Service Letter No. 339

SUBJECT: Insulation of Wiring at Starter Solenoid Switch

MODELS AFFECTED: PA-24 and PA-24-250 Comanches
Serial Numbers 24-1 to 24-1881 inclusive, 24-1883 to 24-1919 inclusive, 24-1921 to 24-1932 inclusive, 24-1934 to 24-1962 inclusive, 24-1964 to 24-1981 inclusive, 24-1983 to 24-1987 inclusive, 24-1989 to 24-2001 inclusive, 24-2003 to 24-2006 inclusive, 24-2008 to 24-2010 inclusive, 24-2012 to 24-2021 inclusive, 24-2023 to 24-2026 inclusive, 24-2028 to 24-2030 inclusive, 24-2032, 24-2033, 24-2035, 24-2037 to 24-2040 inclusive, 24-2042 to 24-2044 inclusive, 24-2046 to 24-2069 inclusive, 24-2071 to 24-2078 inclusive, 24-2080 to 24-2085 inclusive, 24-2087 to 24-2092 inclusive, 24-2094 to 24-2105 inclusive, 24-2107 to 24-2109 inclusive, 24-2113 to 24-2118 inclusive, 24-2120, 24-2122, 24-2123, 24-2125, 24-2128 to 24-2132 inclusive, 24-2134, 24-2135.

SERVICE LETTER 339

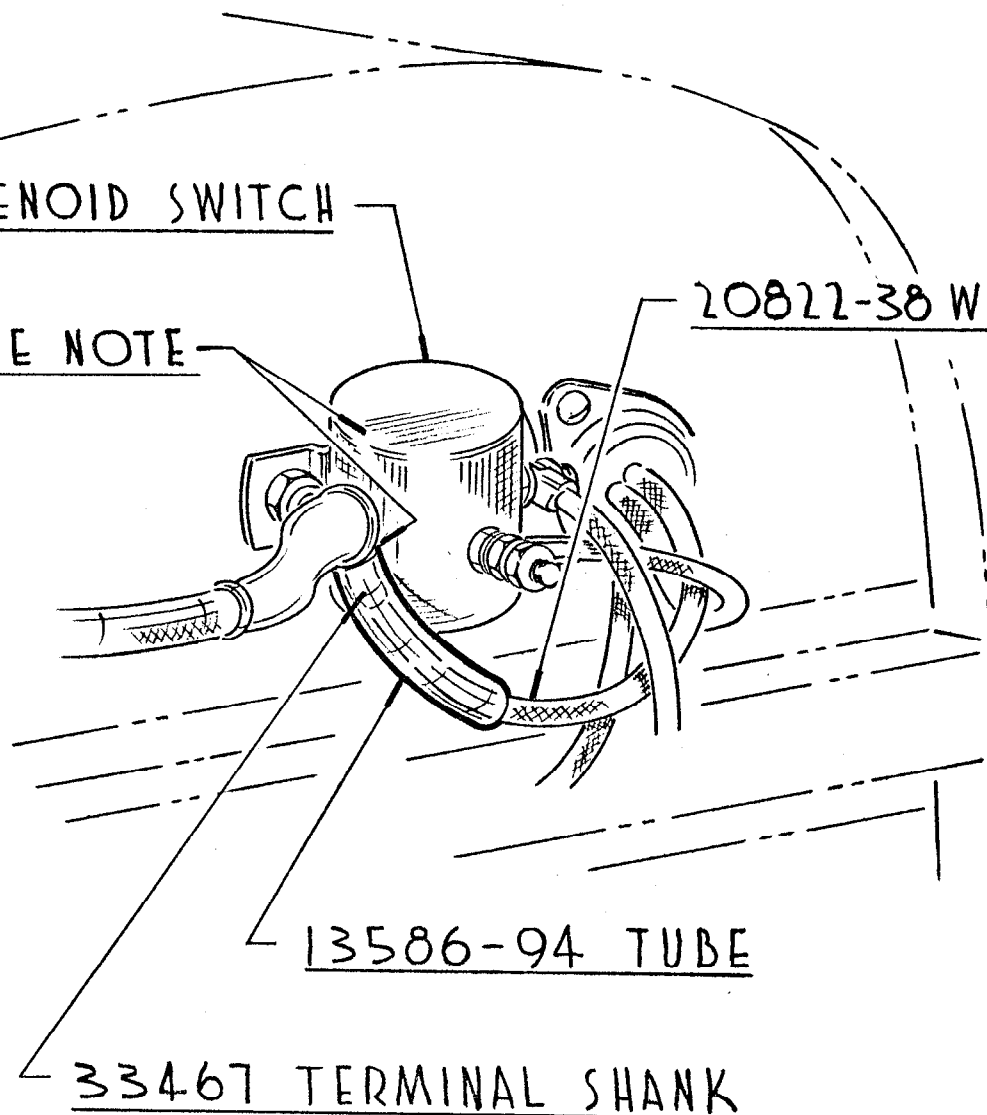
This Service Letter is to advise that a modification has been made to the wiring at the starter solenoid switch. The subject aircraft as indicated by the above serial numbers shall be modified in accordance with the following instructions and enclosed sketch.

1. A piece of plastic insulating tubing, part number 13586-94, two inches long shall be installed over part number 33467, terminal shank, on wire assembly, part number 20822-38.
2. The subject terminal, part number 33467-00, located on the right side of the starter solenoid switch on the forward side of the firewall shall be installed in such a manner as to provide maximum clearance between the terminal shank and the solenoid housing.

The wire assembly, part number 20822-38 installed on Serial Numbers 24-1 to 24-102 inclusive, is of a smaller diameter than those used on succeeding aircraft. The insulated tubing supplied would be of a slightly larger diameter. These must be secured at each end.

INSTALL TERMINAL TO PROVIDE MAX. CLEARANCE
BETWEEN TERMINAL SHANK & SOLENOID HOUSING

INSTALL TERMINAL TO PROVIDE MAX. CLEARANCE
BETWEEN TERMINAL SHANK & SOLENOID HOUSING
